Product Change Notification / SYST-12WUIM914

ERRATA - ATmega48A/PA/88A/PA/168A/PA/328/P Silicon Errata and Data Sheet Clarification

ATmega48A/PA/88A/PA/168A/PA/328/P

Silicon Errata and Data Sheet Clarifications

3.2.1 32M1-A

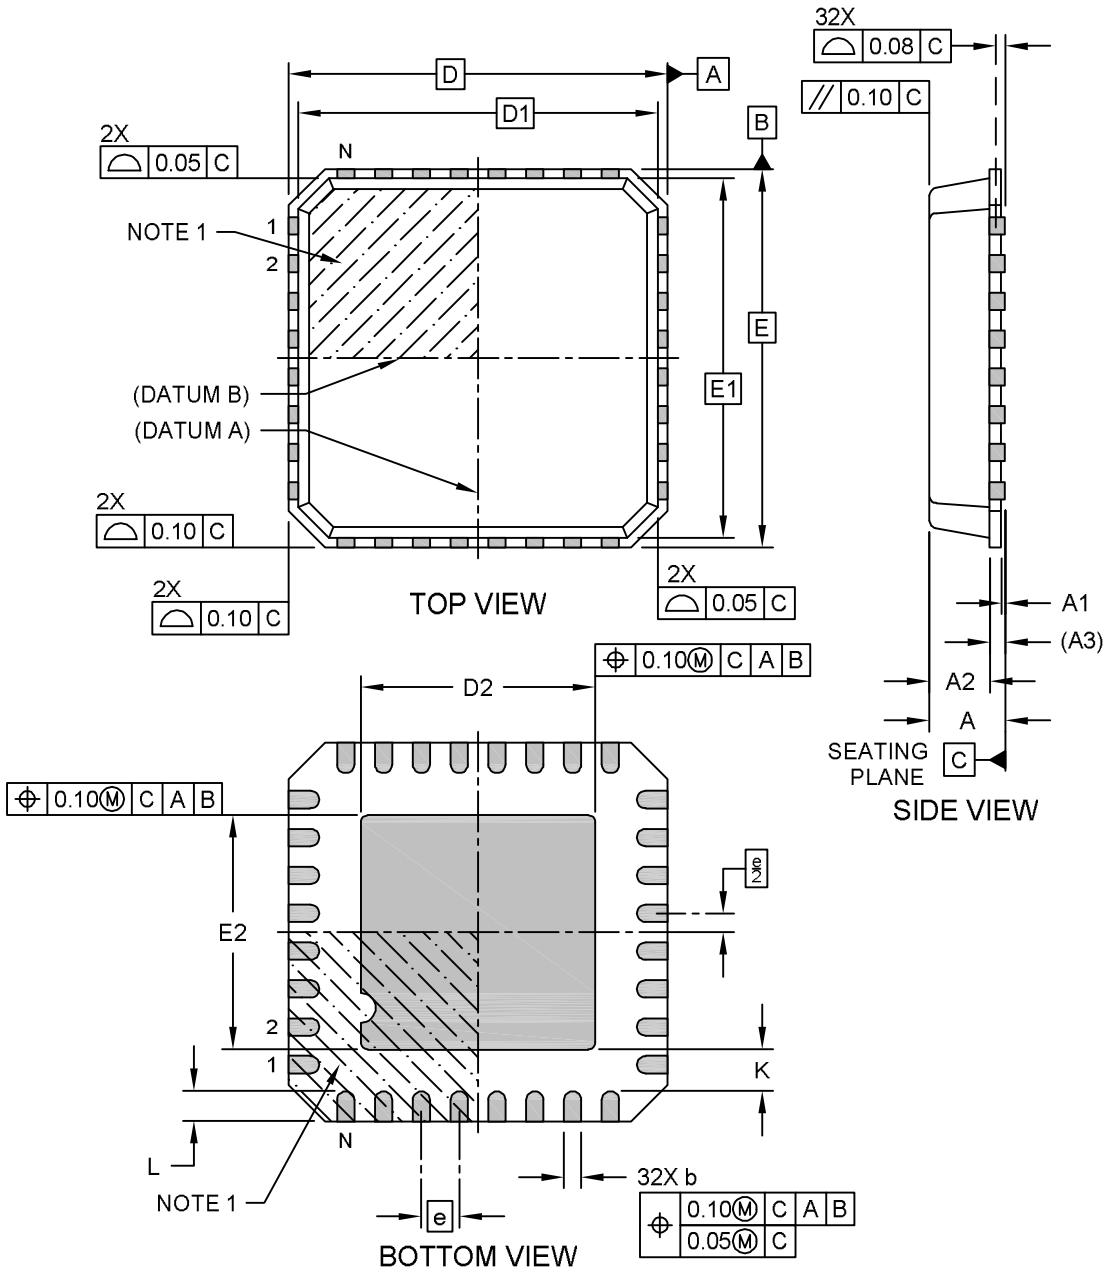
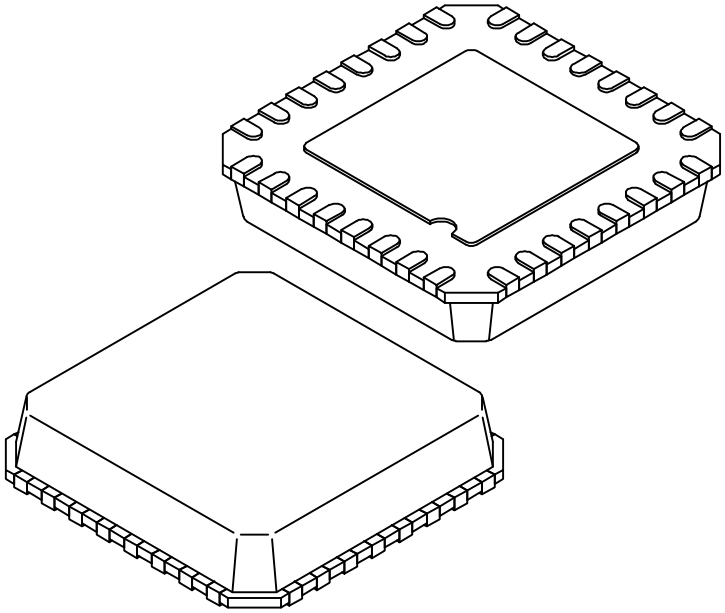
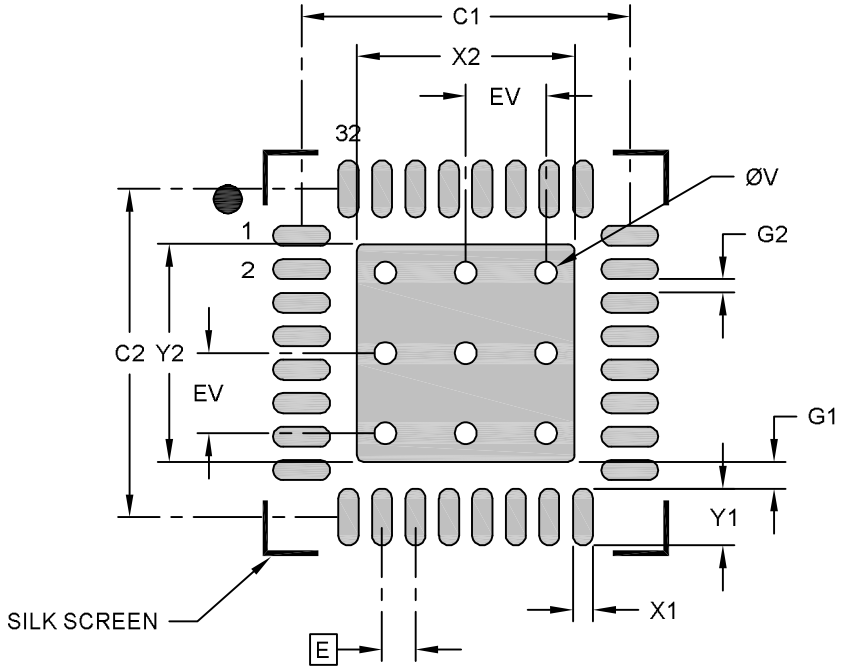
1. **This package type can be delivered with two different styles with reference numbers 'C04-21400' (punched) and 'C04-21395' (sawn) as shown in section 3.2.1 - 32M1-A. For PCB layouts, it is recommended to take both *recommended land patterns* into consideration.**

A clarification about the other package style available for package type 32M1-A has been added to the 32M1-A section.
